## WEST SUSSEX COUNTY COUNCIL CONSULTATION

| <b>LOCATION:</b>           | Montgomery Motors<br>37 Albion Street<br>Brighton<br>BN42 4DN                                                                          |
| <b>SUBJECT:</b>            | AWDM/0723/26<br>Erection of 32 no. flats in six storey building plus associated site works, following demolition of existing building. |

All comments relate to Proposed site layout plan 3471 15 Rev B. This shows the access on the left hand side and has the most up to date cycle and car parking arrangements. 3471 15 REV B

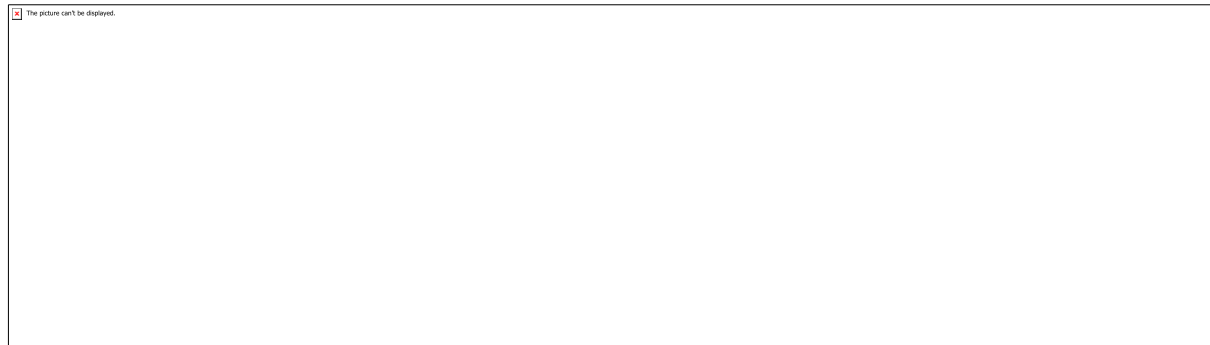
The access to the site will be created using a crossover style access, which is already in place but may require tidying up as it is noticed the kerb edging does not tie into the footway, and the footway here is also in a poor state of repair.

Visibility splays are shown to be 2.4m x 45m in both directions from this access and would be suitable for the speed of the road.

The access road is shown as being wide enough to accommodate two cars passing each other, at its widest it is 5m and narrowest just before the gates at 4.5m.

Whilst a swept path is not provided the dimension of the car park has been considered and it would be possible for a car to park turn and exit in forward gear. As such WSCC would expect to see a minor works licence and s78 agreement showing plans of the minor works required tidy up this access, including the footway. There are also currently two dropped kerb access points into Montgomery Motors and the access not being used will need to be closed and reinstated with a full height kerb. This can be controlled by a suitably worded condition.
